**Item 1**
**6 Shackel Avenue, Gladesville**
**Alterations and additions to existing dwelling house including demolition of existing unauthorised works**

**City of Ryde  
Local Planning Panel Report**

<b>DA Number</b>	LDA2024/0015
<b>Site Address &amp; Ward</b>	6 Shackel Avenue, Gladesville East Ward
<b>Zoning</b>	R2 Low Density Residential
<b>Proposal (as amended)</b>	Alterations and additions to existing dwelling house including demolition of existing unauthorised works
<b>Property Owner</b>	Roumany and Mariam Gadalla
<b>Applicant</b>	Roumany and Mariam Gadalla
<b>Report Author</b>	Shannon Butler – Senior Town Planner
<b>Lodgement Date</b>	24 January 2024
<b>Notification - No. of Submissions</b>	One submission received in objection.
<b>Cost of Works</b>	\$1,730,135.22
<b>Reason for Referral to LPP</b>	Departure from development standards – contravention of the height of buildings and floor space ratio development standards by more than 10% - <i>Schedule 1, Part 3 of Local Planning Panels Direction.</i>

Figure 16 – Proposed western elevation.

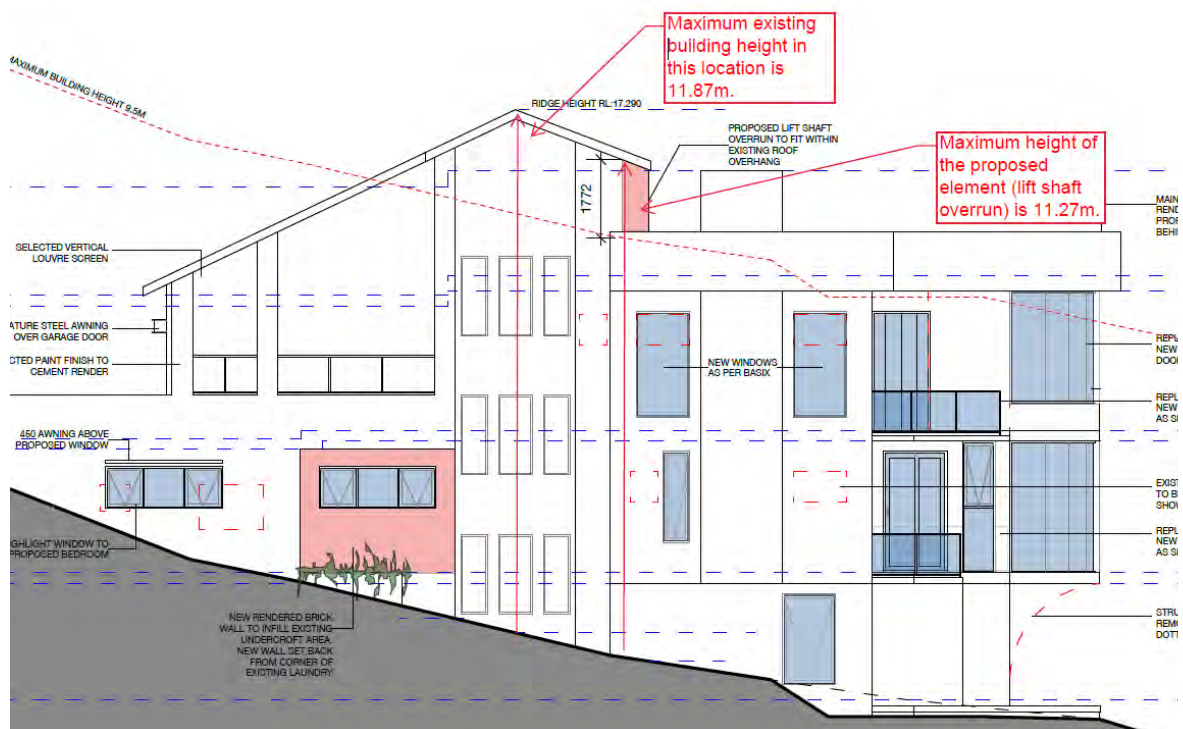
Council has undertaken the height measurement on the western elevation based on the submitted survey which includes contours and a spot level of RL5.42 at the existing ground level at the location of the ridge and the ridge height in this location is RL17.29, resulting in a maximum height of 11.87m on the western side of the dwelling.

Planner's comment: Agreed, the additional element on the rooftop (being the lift overrun) is a minor element that is proposed to be located below the existing roofline and will largely be obscured from view by the roofline and existing structure. The lift overrun will sit below the existing maximum height of the roof ridgeline.

Planner's comment: Agreed, there are no changes proposed to the maximum height of the dwelling as the proposed lift overrun is located under the existing roofline. The lift overrun will be largely invisible from the streetscape. There will be minimal additional impacts resulting from the lift overrun element.

**Figure 17 – Existing and proposed river level floor plans – the additional gross floor area is indicated in orange.**

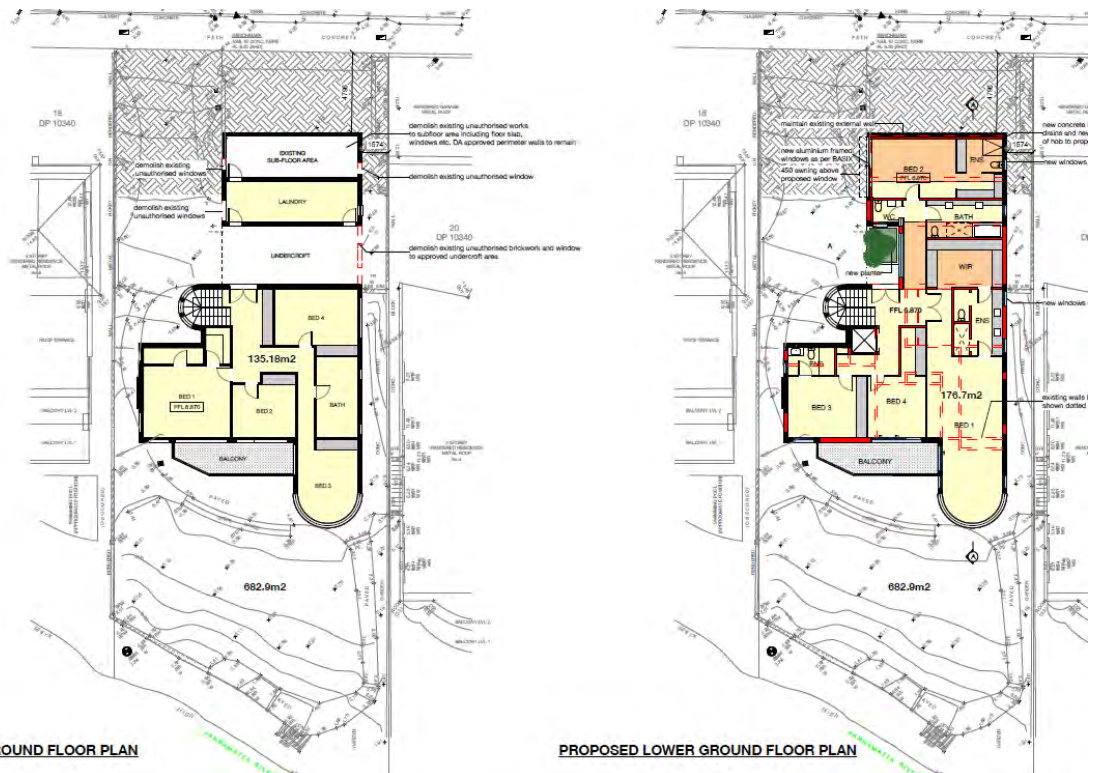
The additional gross floor area proposed within the development results from changes on the river level and lower ground floor as depicted below:

In addition to the above changes, there are very minor changes to doorways on the ground floor and first floor which result in an additional total 1.5m<sup>2</sup> on these floors. The additional gross floor area is created predominately by the change of use of rooms and the enclosure of an undercroft area on the lower ground floor.

DRAWING TITLE	WEST ELEVATION
---------------	----------------

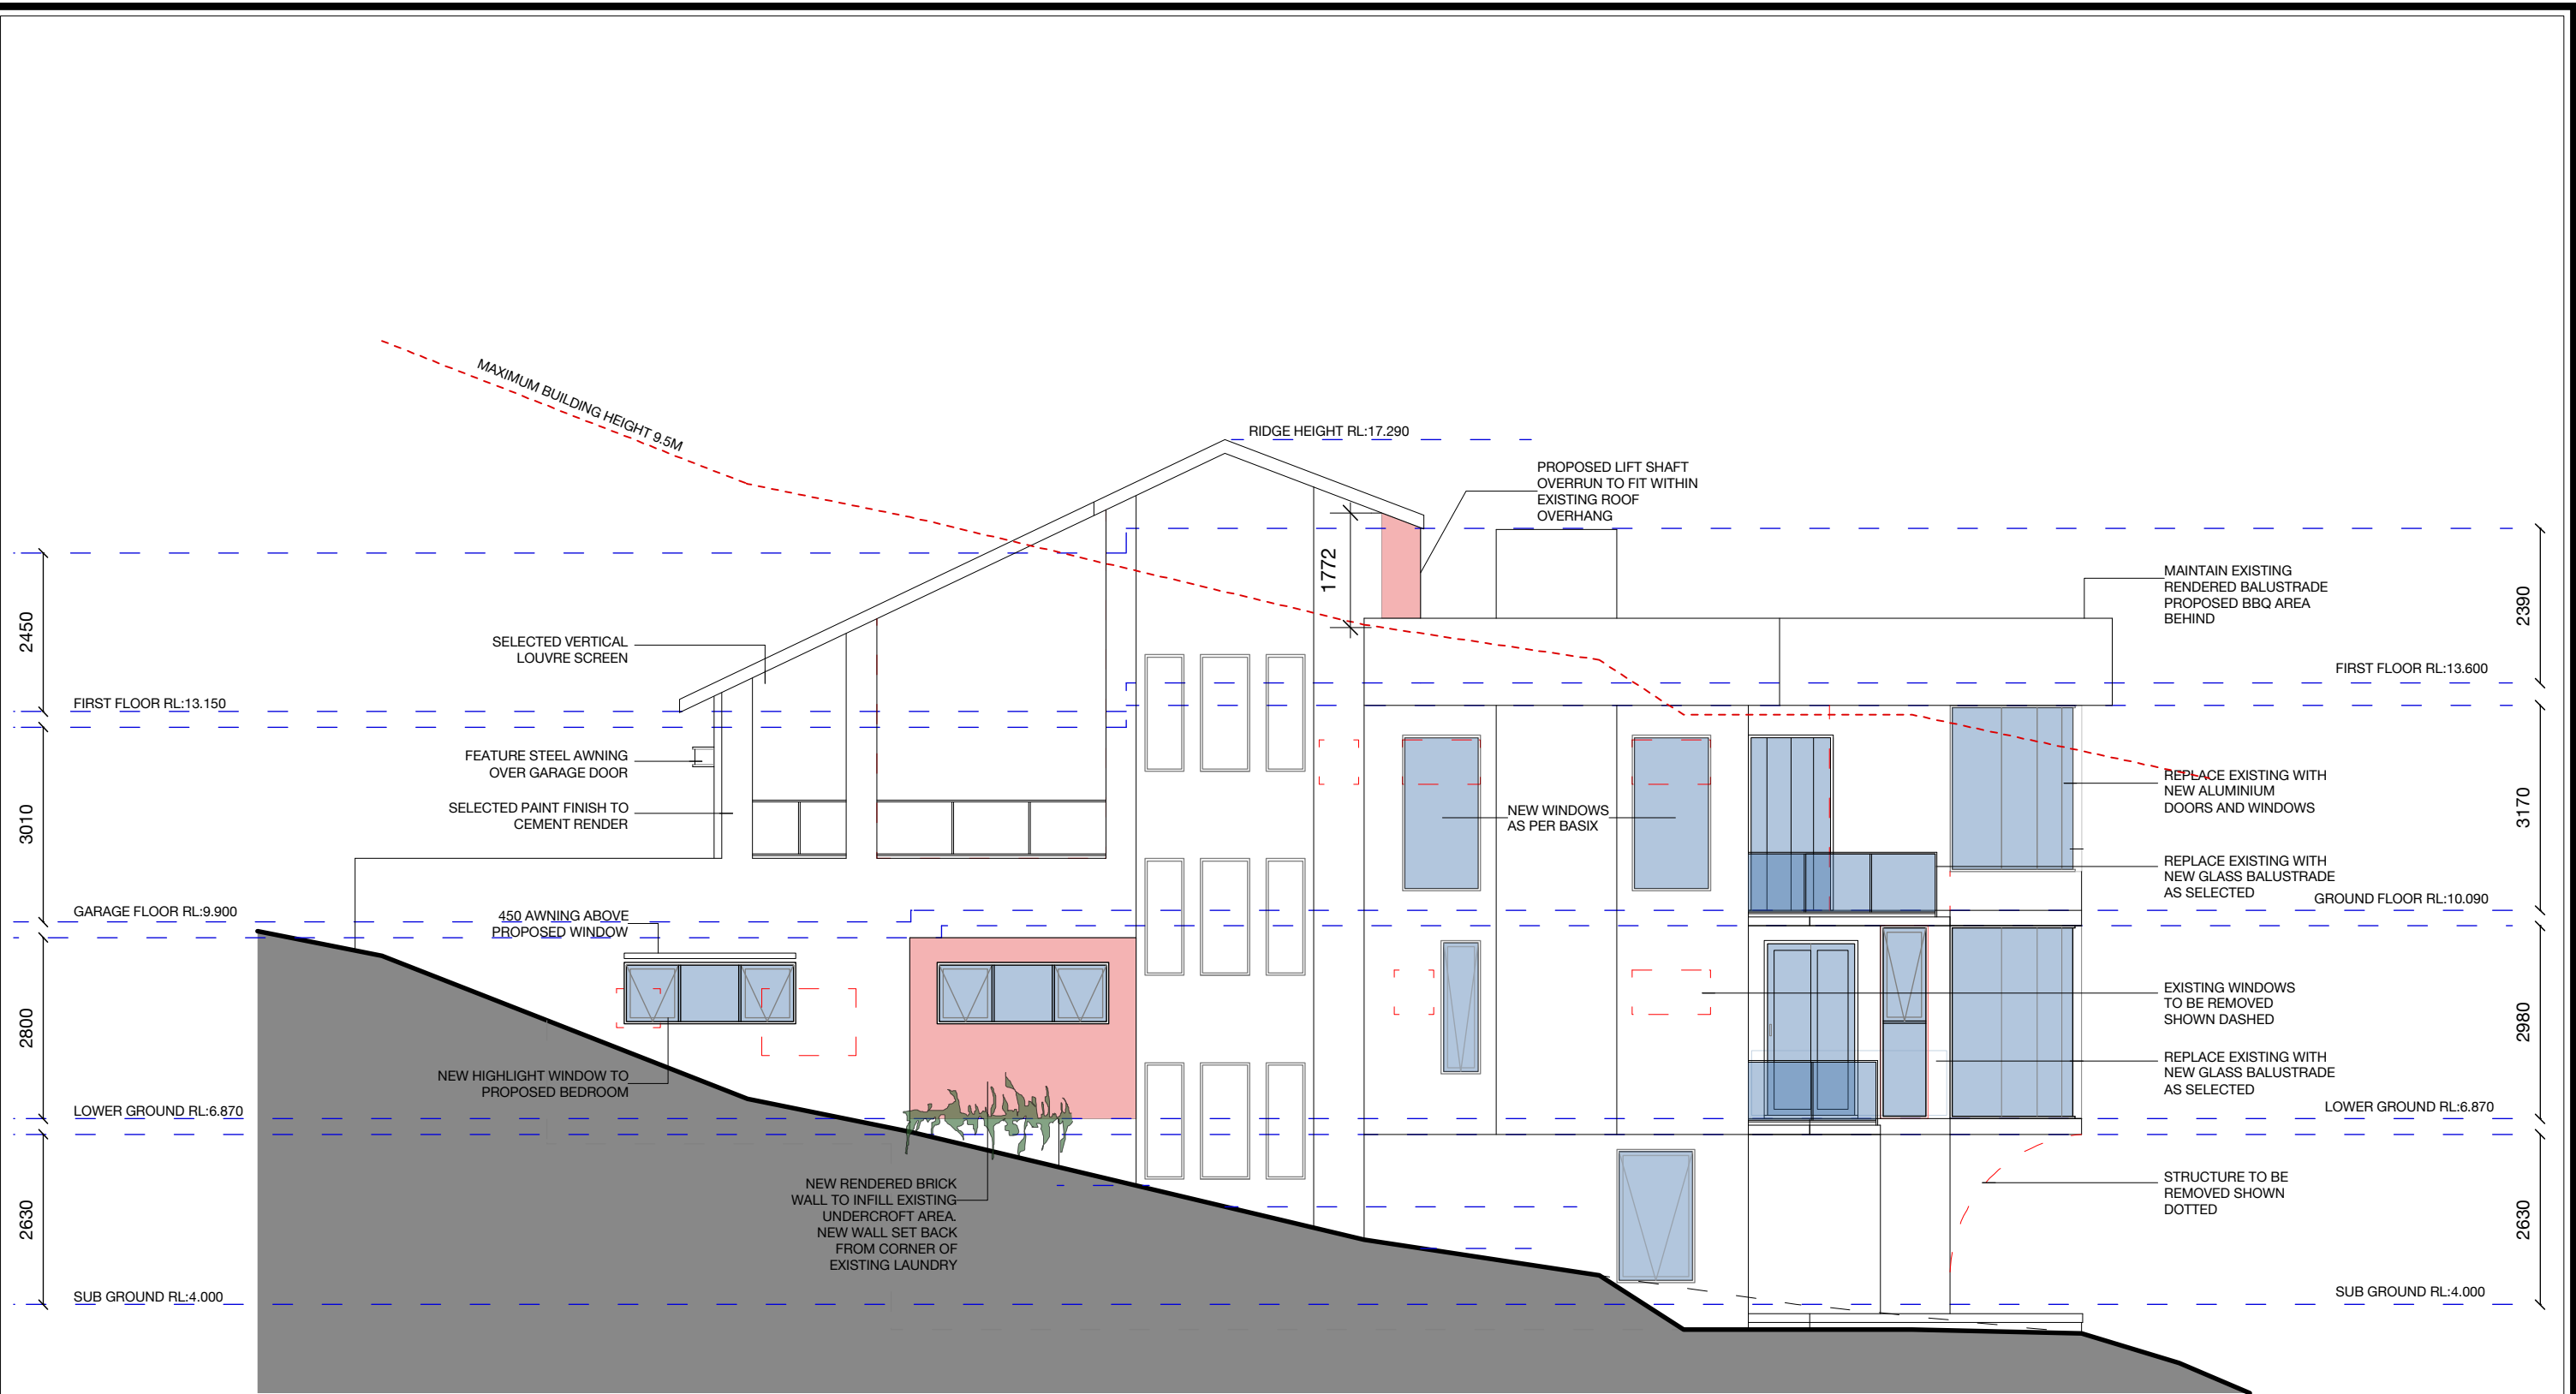
Condition
	<p>curved meals room window is to be amended to comprise obscure glazing where it faces the east.</p> <p>b) The west facing family room windows on the ground floor are to be amended to comprise obscure glazing.</p> <p><b>Condition Reason:</b> To require minor amendments to the plans endorsed by the consent authority following assessment of the development.</p>
